**Renewable Water Resources**  
Greenville, South Carolina

CONTRACT DOCUMENTS  
Reedy River Basin Sewer Tunnel

**ADDENDUM IV - CONTRACT REVISIONS**

October 3, 2017

<b>BLACK &amp; VEATCH</b>  Black & Veatch Corporation Greenville, South Carolina	<b>RENEWABLE WATER RESOURCES</b>  REEDY RIVER BASIN SEWER TUNNEL	<b>PROJECT NO.</b> 192263
	<b>FIGURE 1:</b> <b>TEMPORARY EASEMENT</b> <b>BOUNDARY REVISION</b>	<b>SHEETS:</b> Y04 Y06 C11

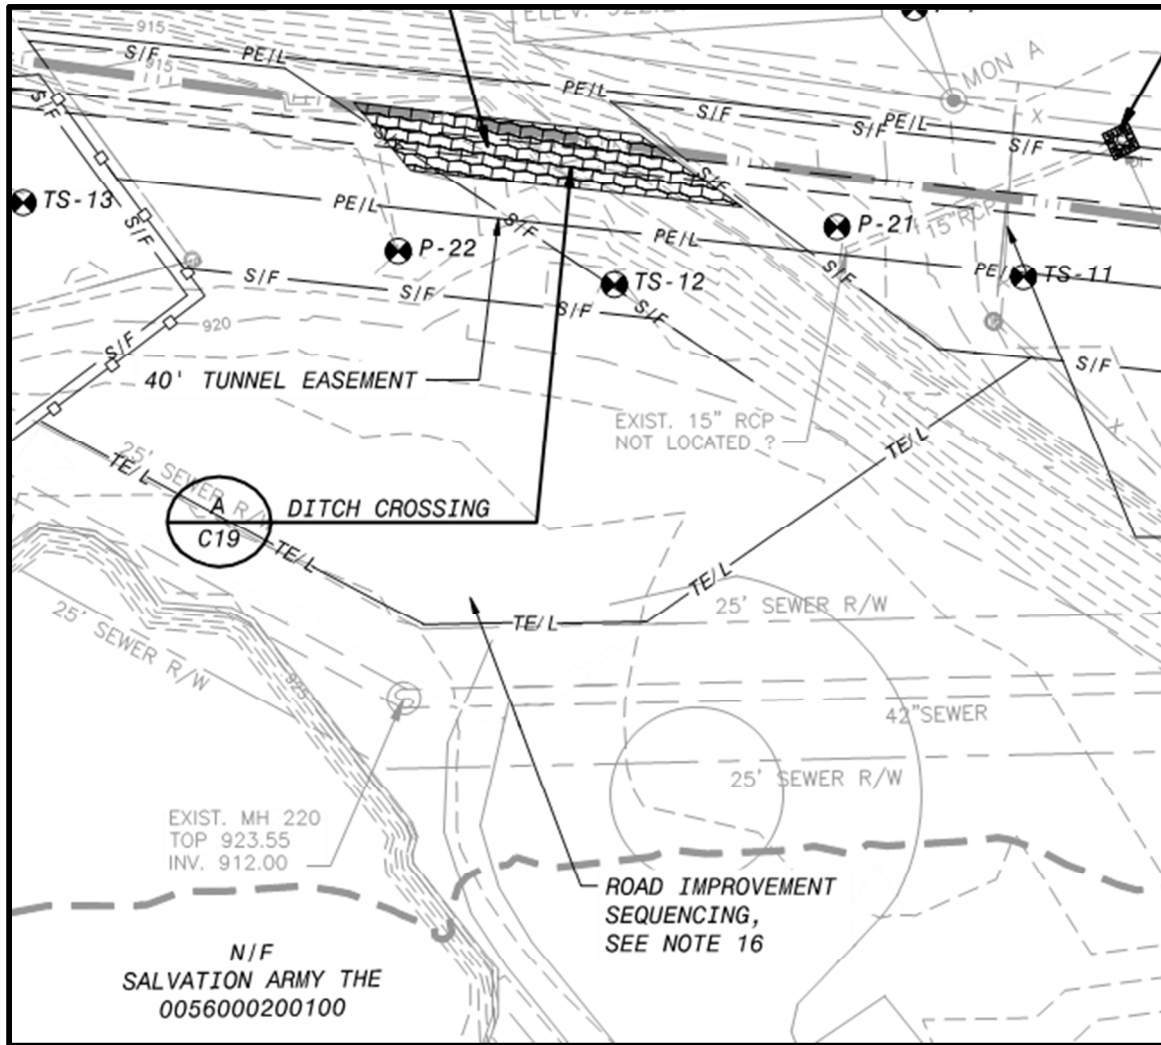
Drawings Y04, Y06, C11. Refer to Figure 1 on page ADIV-5 regarding the temporary easement boundary revision at the Upstream Site.
